UNITED STATES PATENT AND TRADEMARK OFFICE

10/803,051

Office Action Summary	Application No. 10/803,051	Applicant(s) PLANTAN, RONALD S.	
	Examiner Melody M. Burch	Art Unit 3683

DETAILED ACTION

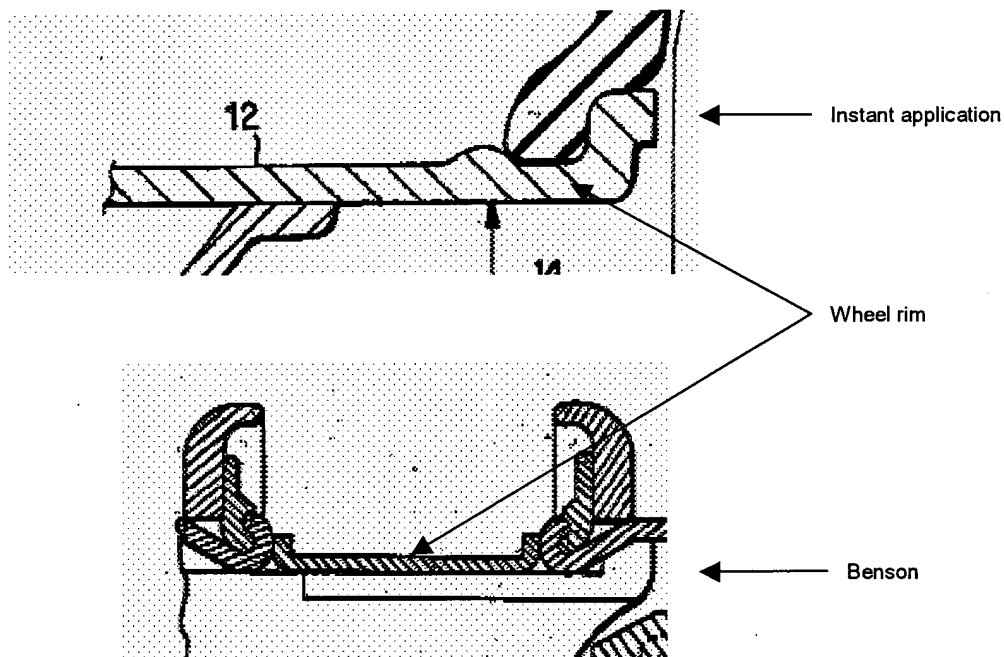
6. Applicant's arguments filed 2/8/06 have been fully considered but they are not persuasive. Applicant argues that "there is no question that Benson's flange 13 extends to a radially outer portion of friction ring 19, and thus does not disclose or suggest the invention in claims 1 and 16." Examiner notes that the portion of the flange 13 in the area of the lead line of number 13 extends from a radially outer region of the hub portion 7 to a radially inner region of the friction portion 19 in the same manner in which one would extend their arms up to the ceiling. A person extends their arms to the ceiling but does not necessarily touch the ceiling. There is nothing in the claim language that precludes such an interpretation. The claim language does not recite an extension that ends in a direct connection. Accordingly, Examiner maintains that, as broadly recited,

the portion of the flange 13 in the area of the lead line of 13 extends to a radially inner region of the friction portion 19.

Also, with regards to the wheel rim, just as Applicant's wheel rim includes a flat piece with crimped edges, Examiner has interpreted the wheel rim of Benson to be the flat piece with crimped edges as labeled below:

Accordingly, the rejections have been maintained.
